**UNITED STATES OF AMERICA
BEFORE THE
FEDERAL ENERGY REGULATORY COMMISSION**

Docket No. ER13-1380-000

**ANSWER TO COMMENTS
AND REQUEST FOR LEAVE TO ANSWER AND ANSWER TO PROTESTS
OF THE NEW YORK INDEPENDENT SYSTEM OPERATOR, INC.**

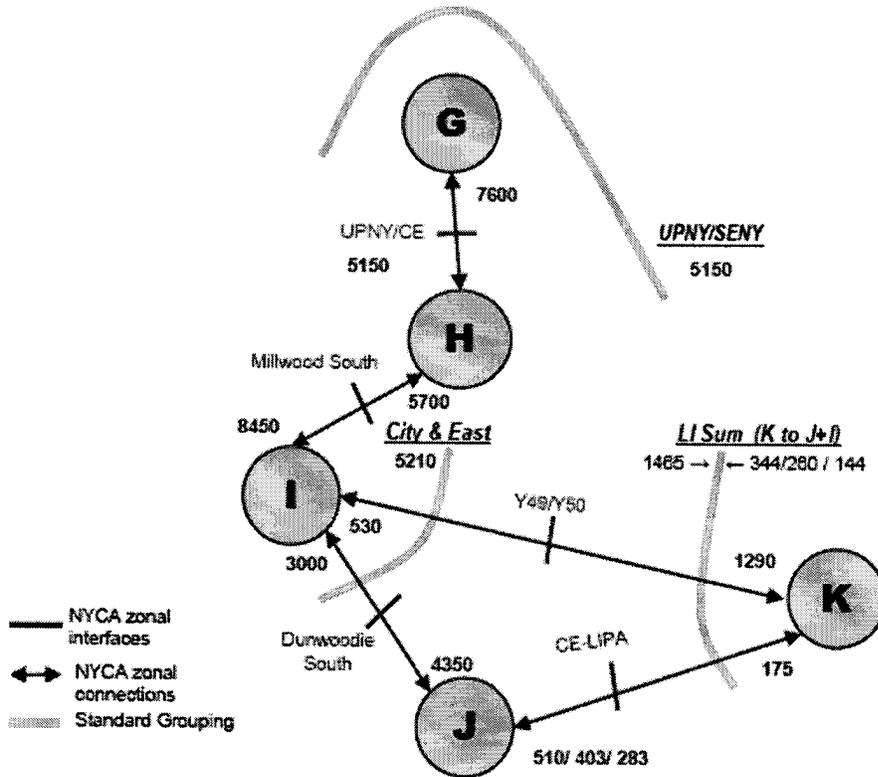
ties/connection to Load Zones GHI but also has ties to Load Zone J. Therefore, Load Zone K can provide support to Load Zone J or Load Zones GHI, or simultaneously to both Load Zone J and Load Zones GHI. As noted by CE/CH and the Sasson Affidavit, the maximum independent transfer capability between Load Zone K and Load Zones GHI is 530 MW, and between Load Zone K and Load Zone J is 510 MW. However, CE/CH and Dr. Sasson fail to recognize that the simultaneous transfer limit between Load Zone K to Load Zones GHI and Load Zone J will often be lower than the sum of the separate transfer limits. CE/CH and Dr. Sasson also fail to recognize that the Load Zone K to J transfer limit of 510 MW is its maximum value, and that the actual value can be as low as 283 MW.

39. Interface transfer limits can have multiple values because they are in large part a function of available generation. The MARS model accounts for both the existence of the simultaneous transfer limit and the variations in transfer limits as available generation changes. It therefore can determine how a transfer limit can vary as a function of available generation.
40. The analysis performed by the NYISO and described in the Chao/Adams Affidavit²⁵ utilized the same transmission topology used for the most recent New York State Reliability Council's Installed Capacity Requirement Study for the May 2013 through April 2014 Capability Year (the "2013/2014 IRM Study"),²⁶ with modifications to three transmission limits from Load Zones J to Load Zone I, Load

Zone I to Load Zone H, and Load Zone H to Load Zone G pertinent to determining the NCZ boundary. The modifications were to the transfer capabilities and were necessary because it is necessary to reflect true transmission capabilities between the Load Zones, in both directions when conducting the fungibility test.²⁷
